ND-2012-0016
March 9, 2012

Subject: **PSEG Early Site Permit Application**
Docket No. 52-043
Response to Request for Additional Information, RAI No. 50,
Identification of Potential Hazards in Site Vicinity

RESPONSE to RAI No. 50

Marked-up Page
2.2-2

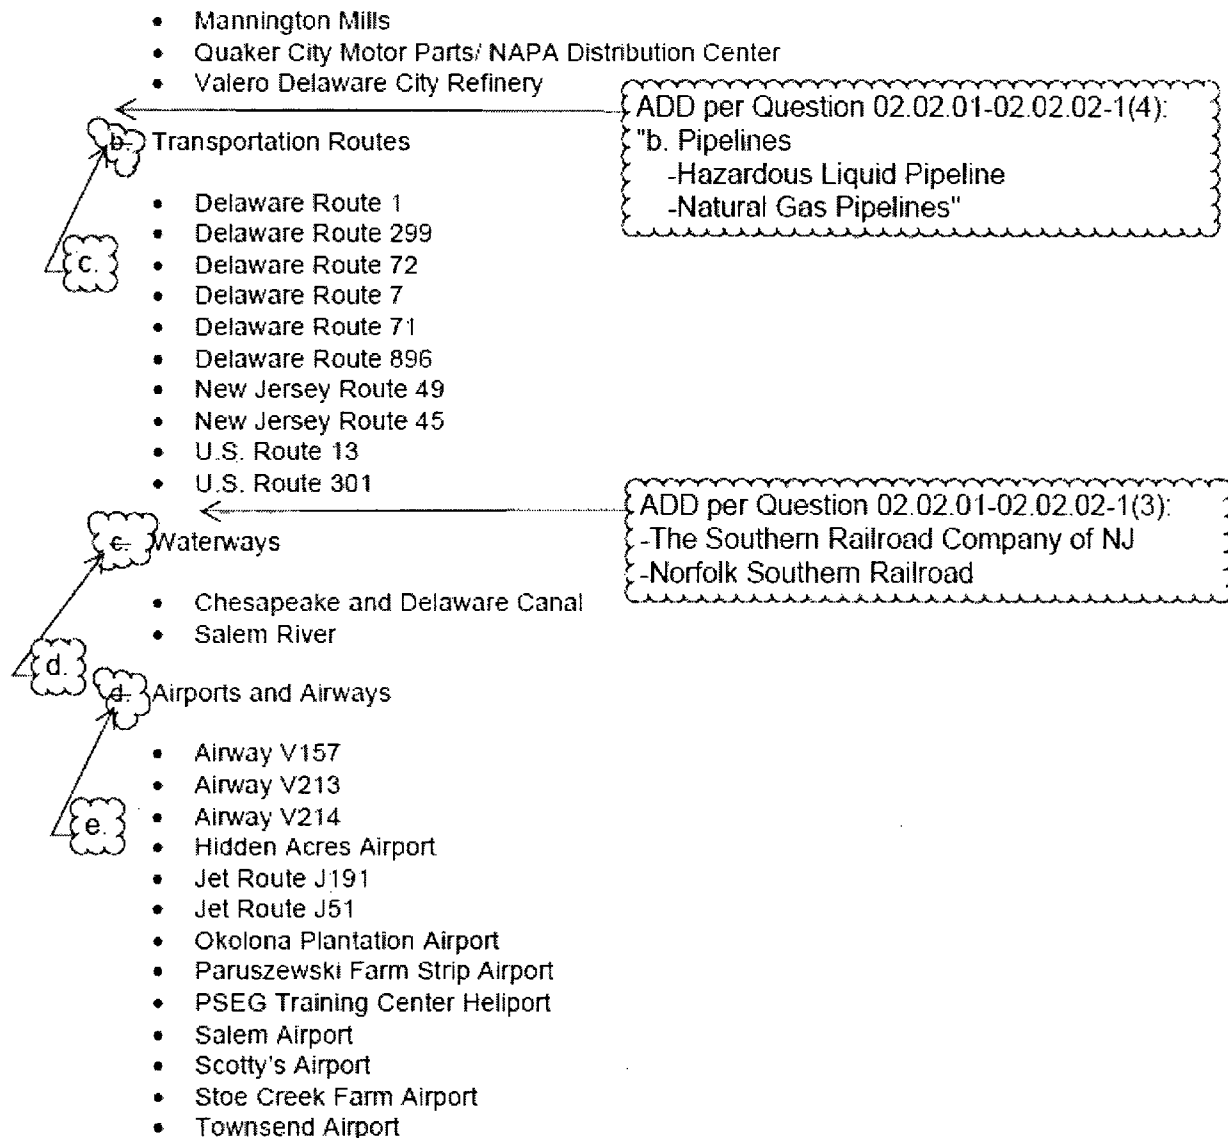
3. The applicant did not list railroads and also did not address the railroad that passes within 10 miles SW through NW of the site, and the spur connection to the Valero Delaware City Refinery. Please include the information, address and evaluate as appropriate.

4. Although a gas transmission pipeline is noted as being 5.9 miles away from the proposed PSEG site in SSAR Section 2.2.2.2, it is not listed among the facilities evaluated in Section 2.2.3. In addition, the staff finds a hazardous liquid pipeline located about 9 miles to the north-northwest near the Air Liquide and Formosa plants. Please clarify, update and evaluate as appropriate.

- (3) There are two inconsistencies with the presentation of railroads in the existing SSAR. The closest railroad is mentioned in SSAR Subsection 2.2.2.6, but railroads are not listed in SSAR Subsection 2.2.1. In addition, railroads are shown but not labeled on SSAR Figure 2.2-1.

Railroads will be added to the list of transportation facilities in SSAR Subsection 2.2.1, and they will be labeled in SSAR Figure 2.2-1. No further evaluation is needed per Regulatory Guide 1.206 Section C.1.2.2.1 and Standard Review Plan NUREG-0800 Section 2.2.1-2.2.2, as all railroads are more than 5 miles from the PSEG Site.

- (4) There are two inconsistencies with the presentation of pipelines in the existing SSAR. The closest pipeline is mentioned in SSAR Subsection 2.2.2.2, but pipelines are not listed in SSAR Subsection 2.2.1. In addition, pipelines are not shown in SSAR Figure 2.2-1.

Pipelines will be added to the list of industrial facilities in SSAR Subsection 2.2.1, and they will be shown and labeled on SSAR Figure 2.2-1. No further evaluation is needed per Regulatory Guide 1.206 Section C.1.2.2.1 and Standard Review Plan NUREG-0800 Section 2.2.1-2.2.2, as all pipelines are more than 5 miles from the PSEG Site.

CD-ROM Containing Revised SSAR Figure 2.2-1

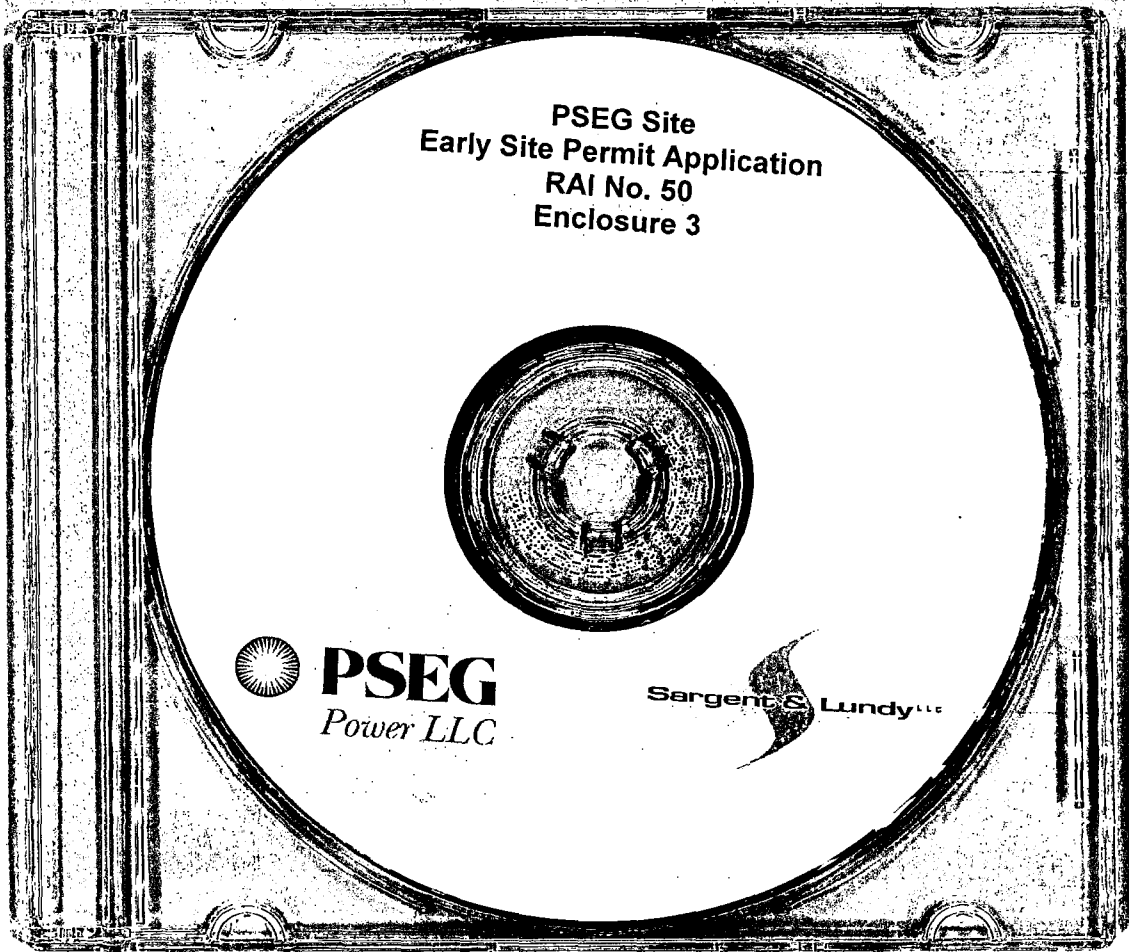
2. The transportation routes (Delaware Route 7 and Delaware Route 896) listed between 5 and 10 miles in SSAR Section 2.2.1 are not shown on Figure 2.2-1, and the routes (DE9, DE25, and DE425) which are shown on Figure 2.2-1 are not listed in the text. Please resolve the inconsistencies.

- (2) There are a few inconsistencies with the presentation of transportation routes in the existing SSAR. Delaware Route 9 is listed in SSAR Subsection 2.2.1 as being within 5 miles, but on SSAR Figure 2.2-1 it appears to be outside of 5 miles. Delaware Routes 7 and 896 are listed in SSAR Subsection 2.2.1, and they are shown but not labeled on SSAR Figure 2.2-1. Routes 25 and 425 are labeled on SSAR Figure 2.2-1 as if they are Delaware state routes, but they are not; in fact, they are minor roads and should not be labeled on SSAR Figure 2.2-1.

The inconsistencies listed above will be resolved by updating SSAR Figure 2.2-1. The figure will be updated to show Delaware Route 9's closest approach to the PSEG Site, which is within 5 miles of the site. Delaware Routes 7 and 896 will be labeled within 5-10 miles of the site. Finally, Routes 25 and 425 will be removed from SSAR Figure 2.2-1 because they are minor roads.
